Reply to Reviewer 1

This paper presents a new coupling procedure between the 3D ocean circulation model CROCO and the spectral wave model WAVEWATCH-III, handled through the OASIS-MCT coupler, in order to improve the representation of wave-current interactions in the coastal region. More precisely, efforts are made to incorporate wave quantities derived from the full (bi-dimensional) wave spectrum that better represents “real” directionally and frequency-broad wave fields. This is in contrast with “monochromatic” approximations that use a representative wavenumber (e.g. mean or peak) as originally used and implemented in ROMS (Uchiyama et al., 2009, 2010).

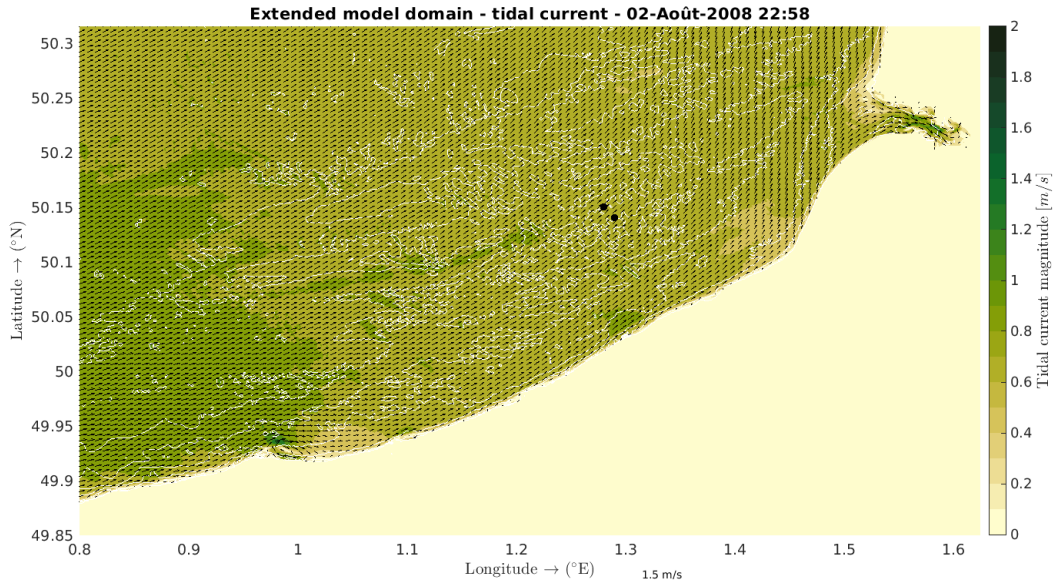
2) The present numerical setup is far from being ideal to discuss the added value of (full) spectral representation of wave quantities, for several reasons. The hydrodynamics simulated here is overly controlled by the forcing used at boundaries, both in terms of water levels, currents and waves, to the point that the reader asks himself what is the added value of using a local model. For instance, the wave results at the measurement site show no improvements over the large scale model used as forcing. Furthermore, water levels and currents are (to my understanding) forced from a 2D hydrodynamic model. Considering the importance given to the vertical shear, how can we be sure that the boundary is taken sufficiently far away from the location where measurements were obtained and vertical velocity profiles discussed? I suspect that the boundary is too close to the measurement stations in order to discuss differences of the order of 1 cm/s at the top layer of the water column.

19) *Why using such a small scale model, which depend so strongly on wave and tidal forcing used at the boundaries? In particular, the tidal forcing is derived from a 2D hydrodynamic model, how does that affect the vertical shear observed at the instrument positions? The discussion of the results presented in the paper depends too heavily on this aspect for being ignored and not investigated.*

Addressing the concern related to water levels and currents, we acknowledge the possibility that the proximity of the southern boundary to the measurement sites could result in an appearance of excessive control by the imposed forcing. To investigate this, we conducted an additional numerical simulation with an extended computational grid in the south and west directions, effectively placing the measurement sites further from the open boundaries. In this

new simulation, we limited the forcing to only the west and north offshore boundaries to assess the independence of the hydrodynamic model results from the relative distance between the forcing boundary and the measurement locations (refer to Figure 1).
